CITY OF PORTLAND, MAINE

Project Name: **Bangor Savings Bank Bank/Office building with two lane drive-through**
Project ID: #2015-080
Address: 20 Marginal Way CBL: 113 A 025001
Applicant: Wendy Durrah, Bangor Savings Bank
Planner: Jean Fraser

PLANNING BOARD REPORT PORTLAND, MAINE

Bank/Office Building with Bank Drive-through, 20 Marginal Way
Level III Conditional Use and (Level II) Site Plan
Bangor Savings Bank, Applicant
Project #: 2015-080
CBL 113 A025001

**CURRENT FINAL PROPOSAL
(Landscape Plan in Plan P10)**

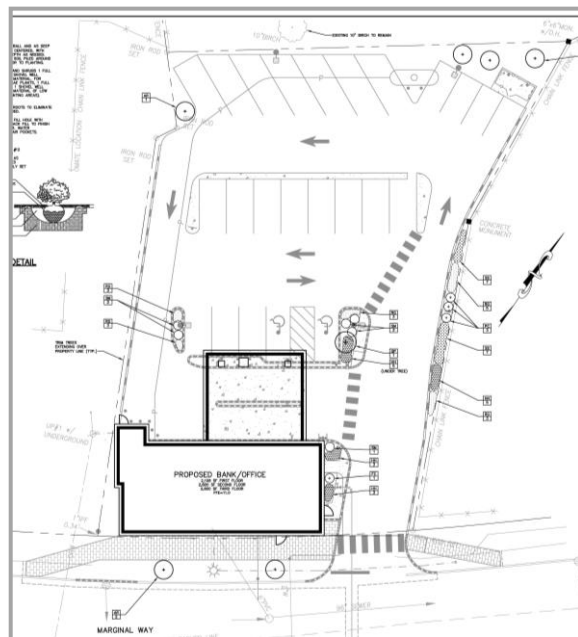
The final Landscape Plan (Plan P10) has been prepared by a Landscape Architect and includes many improvements, although the City Arborist remains of the view that more could be done (Attachment 3):

The proposed Bangor Savings Bank landscape plan for Marginal Way is acceptable with the condition that ONE tree is planted in the rear right side traffic island and vegetation is added to the proposed rear curbing area.

The attached photos demonstrate that ornamental grasses can grow in restricted spaces, this is an MDOT project called Hagis Parkway / Route One in Scarborough where they successfully use beach grass in a high salt area with good results. The overall Bangor Savings Bank project has much less than average landscape percentage due to lot orientation and circulation patterns, however a simple planting of low maintenance beach grass would work, thus is a recommended condition of approval.

- iv. That the applicant shall submit a revised Landscape Plan, for review and approval by the City Arborist and the Planning Authority prior to the issuance of a building permit, that adds one tree to be planted in the rear right side traffic island and adds vegetation to the proposed rear curbing area to address the City Arborist comments dated 7.2.2015; and

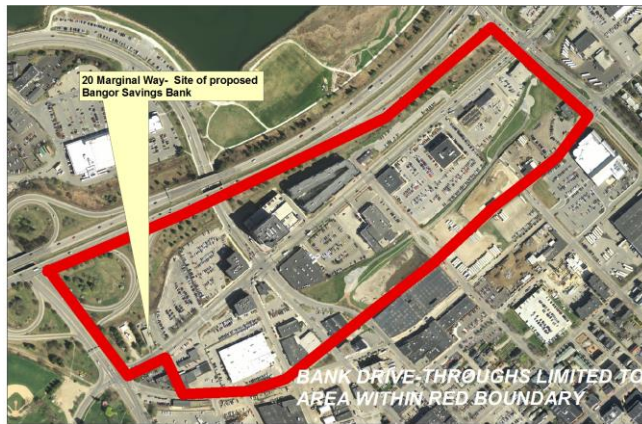
Staff comment: The proposed vehicle circulation takes the drive-through customers around the rearmost drive and then down the west side to enter the drive-through from the west. This provides stacking area along the west boundary of the site and ensures that it is not near Marginal Way nor across any pedestrian routes.
